AERONAUTICAL CHARTING MEETING
Charting Group
Meeting – October 24 - 25, 2018

RECOMMENDATION DOCUMENT

FAA Control #18-02-328

Subject: Standardizing RP* Notation to prevent pilot’s from interpreting it as “Right Pattern, All Runways”

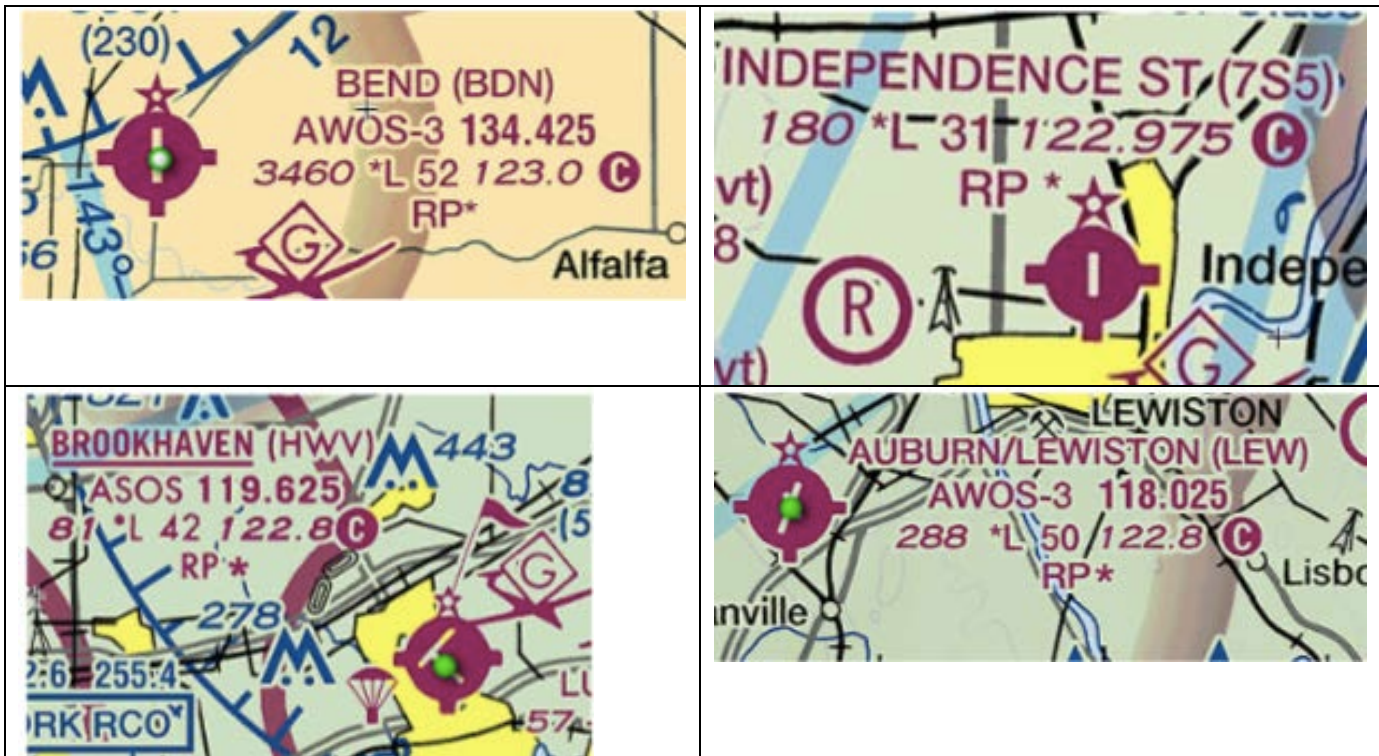
More importantly, let’s compare a few different ways this notation *actually* appears on charts:

While “*” appears in these airports after RP in some way, it is incredibly inconsistent; Sometimes it is attached to RP, sometimes there is a space; sometimes it is bold, sometimes it is not; and most importantly, sometimes it is a superscript (RP^{*}) sometimes it is not (RP *).

As an interface designer, I contend the latter is the most problematic in terms of inducing pilots to error. Given the font height and weight, pilots who aren’t well aware of the notation can easily interpret that the * is substituting for runway markings – after all, they normally see runways in that same font size and location where that symbol is located! Therefore, it is easy to see why some of them would see the asterisk (especially when written as RP *) as indicating that all runways are right pattern traffic, especially considering how in many industries * is used as a wildcard symbol (for instance, in the popular SQL programming language, * is used to denote “all items”)

Standardize the RP^{*} to more closely match other chart notation. Along with pilot-controlled lighting, put the asterisk as *preceding* RP so as to avoid pilots thinking that the asterisk is there in place of runway numbers (*RP). At the very least, ensure that the asterisk is applied consistently across all airports as a superscript, avoiding issues like what you see at KHWV which strongly lead a pilot into thinking that the * is there in place of runway numbers.

Rick Fecht, FAA/AJV-5223, said that inconsistent depiction of the notation on the charts is due to old fonts being mixed in with new fonts. He said the Visual Charting Team will fix the inconsistent depiction on the charts. For the notation to change to *RP, there would have to be a specification change processed.

Valerie polled the audience and determined that there is concurrence for the revised depiction to *RP when a user needs to go to the Chart Supplement to read the details of which runways use right traffic and for what types of aircraft. She said she will draft an Interagency Air Committee (IAC) Specification change to standardize the depiction of the asterisk on the charts and the Legend. She will also look at the language in the Chart User's Guide and Aeronautical Information Manual (AIM) to see if it sufficiently explains the meaning of the asterisk in the RP notation.
